## N4962A-01

# S E R V I C E N O T E

## N4962A Serial BERT 12.5 Gb/s

Several N4962A bit error rate testers were shipped/repared with an incorrect firmware version.

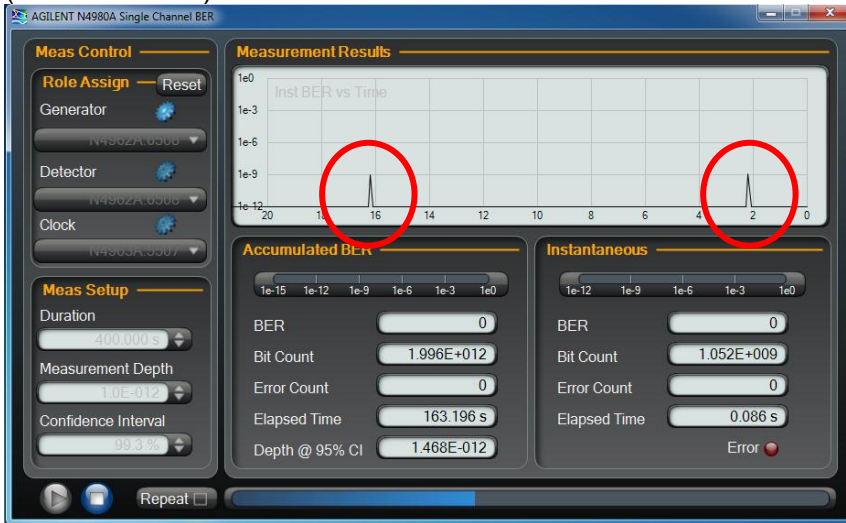
Some N4962A 10G BERT's have been reported to periodically (several times a minute) return an incorrect value when queried for BER results. The incorrect value can be the time stamp, bit count, or error count, and subsequent queries will return the correct values. When using the N4980A software single channel BER measurement, the output may look like this (see red circles):

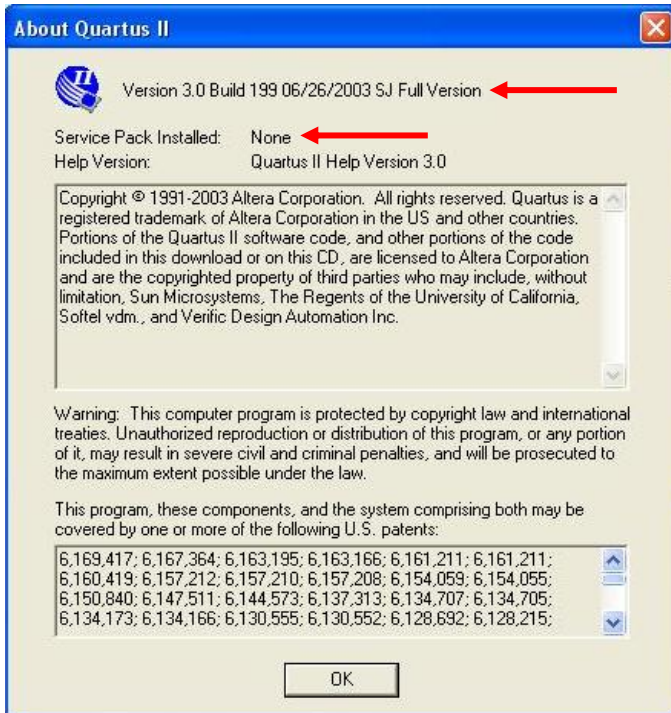
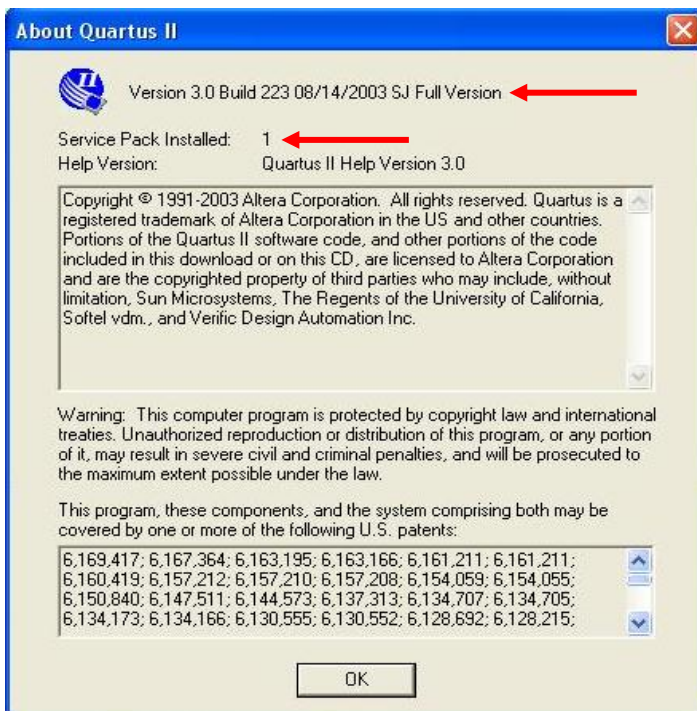
The cause of this behavior has been identified and fixed. The wrong build of firmware compiler was used for a time at the factory and was introducing this error.

Incorrect version:

Correct version:

The solution is to recompile and reinstall the N4962A firmware using the correct compiler version.
